**NOTICE OF  
SPECIAL MEETING OF THE PLANNING AND ZONING COMMISSION  
REMOTE MEETING  
1-888-475-4499  
MEETING ID: 834 4056 3082  
THURSDAY, FEBRUARY 25, 2021, 6:00 PM**

- 1.** Discuss, consider and act on a recommendation for a Site and Landscape Plan for Domino's Pizza located at 1043 Hickory Creek Boulevard. The property is legally described as Wal-Mart Addition, Block A, Lot 7R (n pt).

**RE: Domino's – Site Plan  
2<sup>nd</sup> Review**

**Re: Site Plan Comments – Domino's  
1<sup>st</sup> Review**

SHEET  
SP1

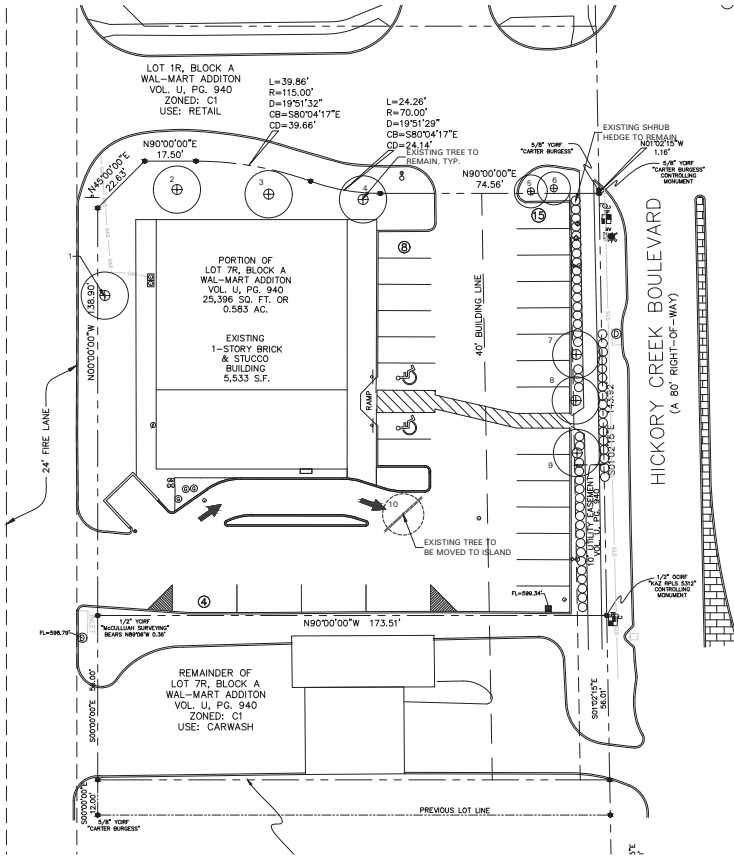
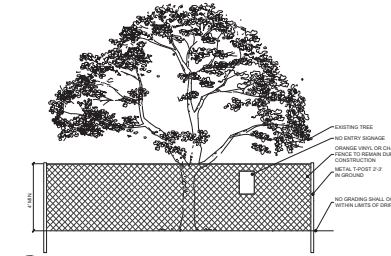
1. Add traffic flow arrows, grate inlet, and curb inlet to the legend.  
*Added as requested.*
2. Include a note indicating the area shown on the site plan is not in a floodplain and reference the FIRM for the area used in determining this.  
*Note added as requested.*

3. Please indicate the location of water and sewer lines.  
*Existing water and sewer lines added per available Record Drawings.*
4. Is there a sewer cleanout in the proposed drive through lane? Symbol present but not labeled like others.  
*Sewer cleanout labeled.*

5. Please label the radii in the beginning of the drive through that are not 2-foot radii covered by the note.  
*Have labeled as requested.*
6. Are the traffic flow arrows shown on the plan to be pavement markings, also? Please clarify.  
*Yes, they are pavement markings and have been added to legend for clarification.*

7. By Town ordinance all parking spaces are to be no less than nine feet by 18 feet. The parallel spaces proposed are eight feet in width. If these are widened to nine feet, the drive lane is reduced to 10 feet in width, which is too narrow. Suggest eliminating one row of spaces or narrowing landscaped median instead.  
*Eliminated the two parallel spaces adjacent to the drive thru lane and have widened the remaining parallel spaces to be nine-feet wide. The drive lane has also been widened to be 20-feet.*

8. With one-way operation on the south end of the site, how do vehicles entering the parking lot heading south exit if all spaces are full? There is no way to turn around. The parking requirements for the site uses is 24 spaces. 29 are proposed in the plan. Suggest eliminating one row of parallel spaces and shifting or narrowing landscape median to widen the remaining parallel spaces to nine-foot minimum, and provide a minimum 20-foot wide, two-way drive lane. The drive through lane can be reduced to less than 12 feet wide.

*Eliminated the two parallel spaces adjacent to the drive thru lane and have expanded the driveway to be 20' wide as suggested.*
